ENGINEERING CHANGE REQUEST

Installation of MiniDT at SND Experiment

This document specifies the procedures, timing, materials, and tooling to organise the works to be carried out in TI18 for the installation of the MiniDT in Q1-2025 during Year-End Technical Stop (YETS) 2024/2025

Figure 2 - View of current configuration of SND experimental area in TI18. Highlighted are the position planned for the installation of MiniDTs (red) and the gas bottle location (green).

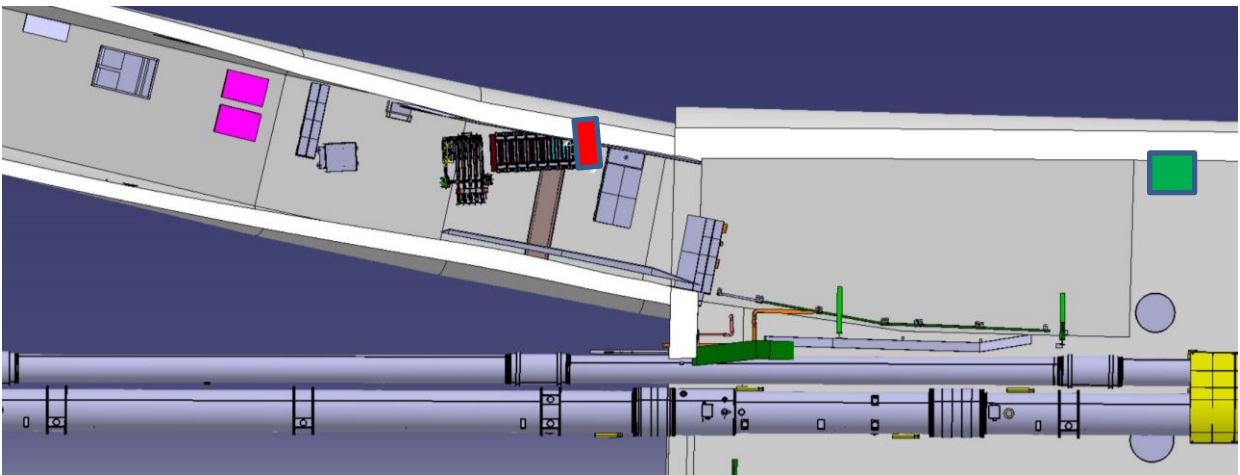
A gas system will be installed too. A standard (50L, 200 bar) gas bottle with pressure regulator and fluximeter will be stored in UJ18, where wall fixings are already available, and 4-mm copper gas pipe will be installed to reach the MiniDTs at their position in TI18.

Figure 5 - Top view of MiniDT chambers installed in SND@LHC.

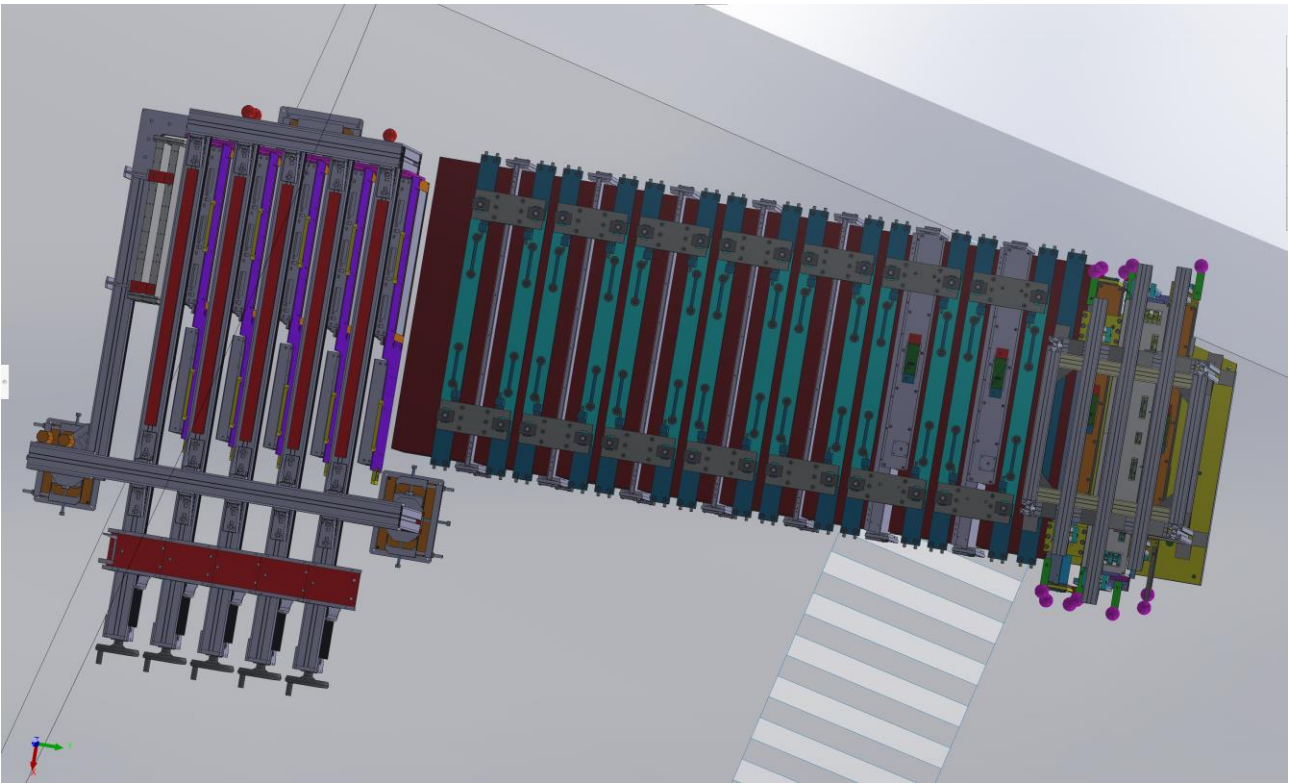
The installation of MiniDTs will take place in TI18. A modification to DS4 support structure is proposed for the installation - Figure 5. The MiniDTs will be positioned almost at the end of the current muon system as they are to be inserted between DS3 and DS4. In this position they will not interfere with any work to be done around the detector, e.g. emulsion replacement.
